Economic Commission for Europe
Inland Transport Committee
World Forum for Harmonization of Vehicle Regulations
Working Party on Lighting and Light-Signalling
Seventieth session

Geneva, 21-23 October 2013

Report of the Working Party on Lighting and Light-Signalling on its seventieth session
Contents

"Figure 2.

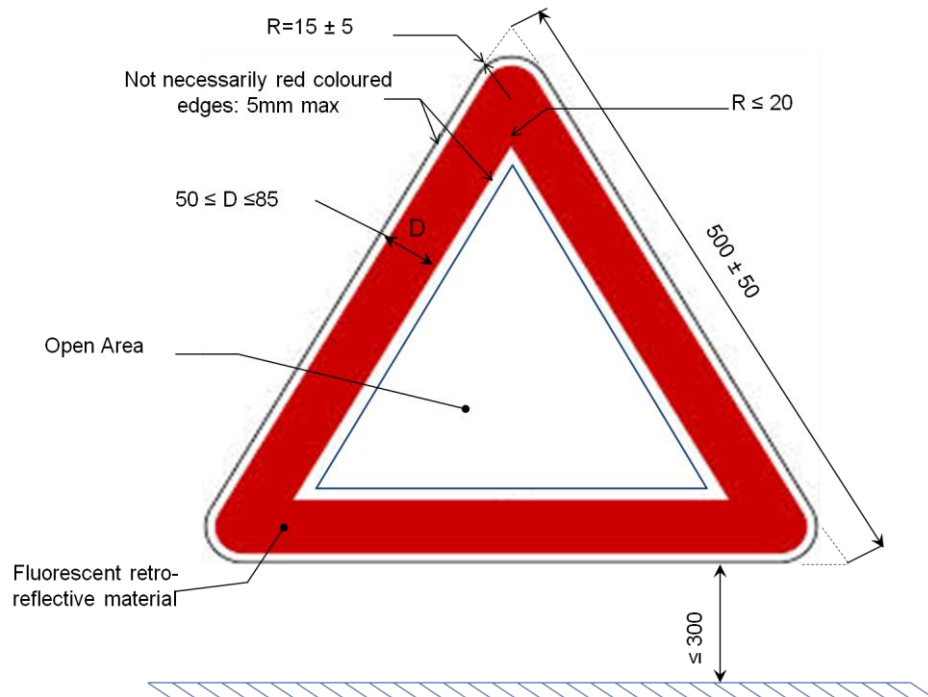
Annex 3, insert a new Figure 2., to read:

Shape and dimensions of the advance-warning triangle of type 2 and of the support

**"Figure 2
 Impedance of HV artificial network**

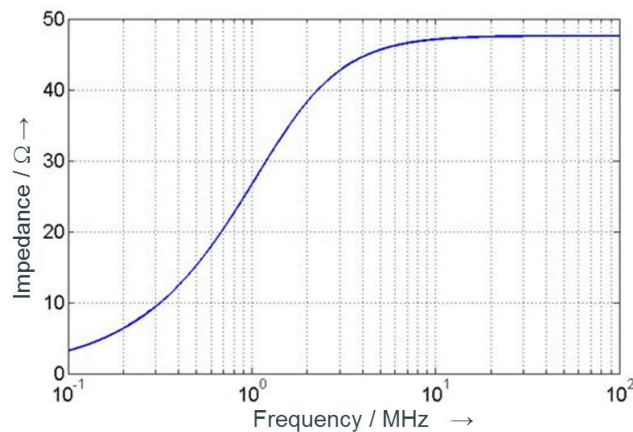
Appendix 8, figure 2, delete and replace by:

Figure 1
ESA in configuration "REESS charging mode coupled to the power grid" - Coupling between lines for DC or AC (single phase) power lines.

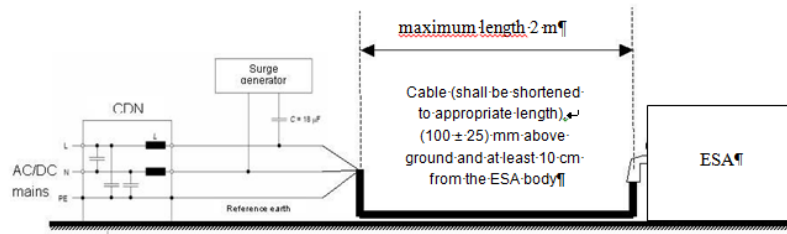
Annex 22, Appendix, Figures 1-4, amend to read:
